June 26 2020

Subject: Response to Comments  
 Proposed Delivery Station  
 1800 Lower Road  
 City of Linden, Union County, New Jersey

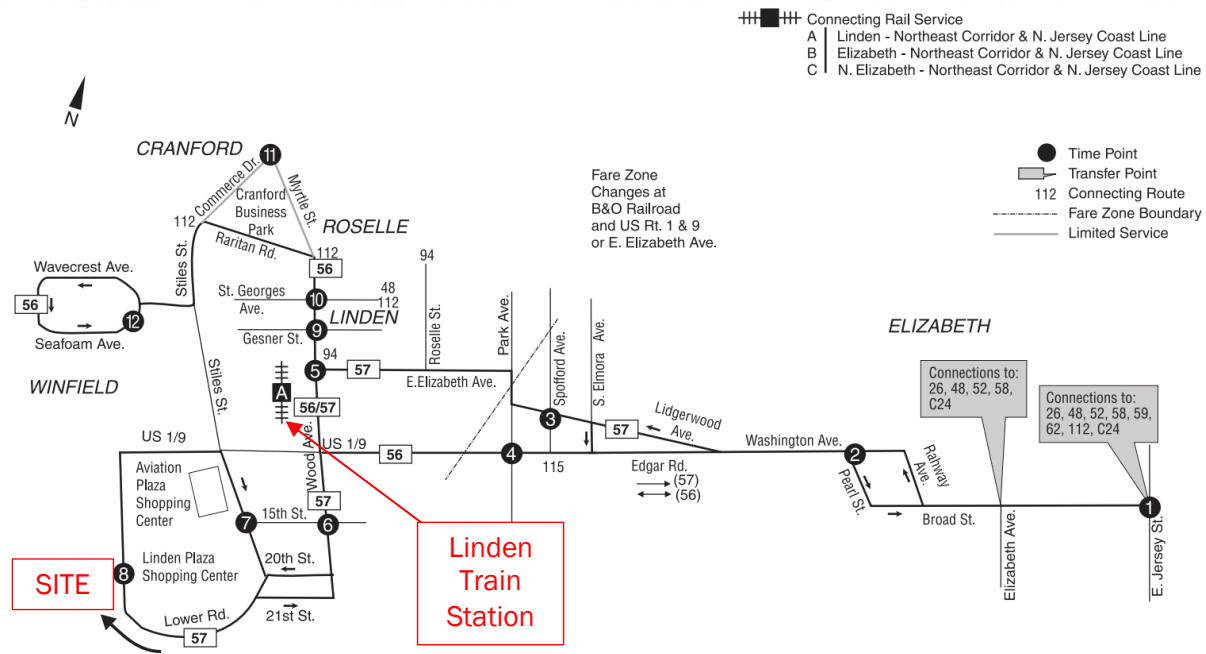
10. *The applicant shall provide an exhibit showing the available NJ Transit bus routes in the area. The applicant shall provide a plan to encourage mass transit usage by the tenants of the site. The applicant shall provide testimony regarding the potential maximum population of employees, particularly at shift changes. The applicant shall notify NJ Transit of the potential for new ridership to and from this site.*

As indicated in the response to comment #9 above, the #57 bus route provides direct access between the site and the Linden Train Station. The annotated excerpt from the NJ Transit #56/57 Bus Schedule, shown below, indicates the available mass transit options for the site.
